Detailed Site Plan Alternative Compliance Communicare Health

DET-2023-005
ACL-2025-001

STAFF REPORT

SUBJECT: Detailed Site Plan DET-2023-005
Alternative Compliance ACL-2025-001
Communicare Health

Figure 1: South Building Elevation Facing Marlboro Pike

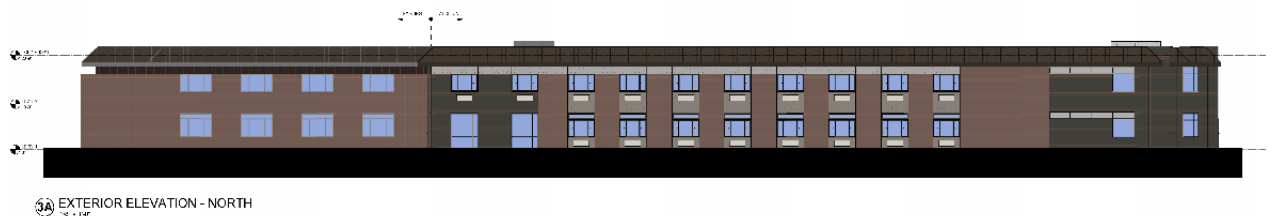
The architectural elevations submitted with this DET show a variety of building materials used for the proposed addition, including bricks, brick veneer, and fiber cement panels. The materials are shown in a variety of colors, such as bark, rich espresso, and timber bark. The existing building façades feature dark brown brick, and the existing roof is mansard roof with brown asphalt shingles. The proposed addition maintains the existing mansard roof shape. The standing seam metal roof will be used uniformly throughout both the existing building and new addition, enhancing visual cohesion and durability. The proposed façade and roof materials ensure a seamless and cohesive transition between the existing building and proposed addition. Upon reviewing the black-and-white elevation, staff find an inconsistency in the roof materials labeling. A condition is included herein to revise the black-and-white architectural elevation with clear labels, ensuring consistency in roof material labeling.

- j. Add the required and proposed transparency percentage to the building elevations, to demonstrate conformance to Section 27-61203(d)(1) of the Prince George's County Zoning Ordinance.

- k. Revise the black-and-white architectural elevation with clear labels, ensuring consistency in roof material labeling.
- l. Revise the photometric plan as follows:
